**RE: Creekwalk North Development Plan and Plat Projects  
AR DP 21-00551 and AR FP 21-00552**

Kimley-Horn and Associates represents the planning and engineering team for Creekwalk North Development Plan and Plat projects (City Numbers: AR DP 21-00551 and AR FP 21-00552). In response to the January 20, 2022 appeal letter submitted to the City, the following responses have been provided.

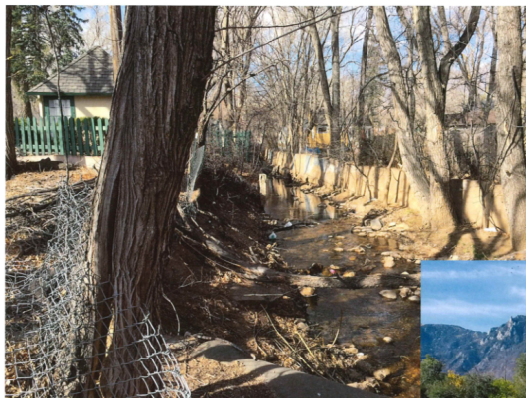
2. The Development Plan and Plat Will Result in Unreasonable Auto Traffic
  - *Response: The development plans for both Creekwalk North and South have actively worked City traffic and CDOT to address traffic access and level of service concerns in the area, improving the current conditions. This includes the addition of a new traffic lane on Cheyenne road, the reduced number of access point along Cheyenne Road and South Nevada Ave, and the study of signalization in the area.*

While not all of the signalization work is completed with the Creekwalk Development Plans, the projects will have made improvements with the signals at Cheyenne road and Roanoke St., and the alignment at

Ramona Ave. The project is also making large improvements in pedestrian facility and access with streetscape improvements along Cheyenne Road and South Nevada Ave and through the extension and development of public access along Cheyenne Creek.
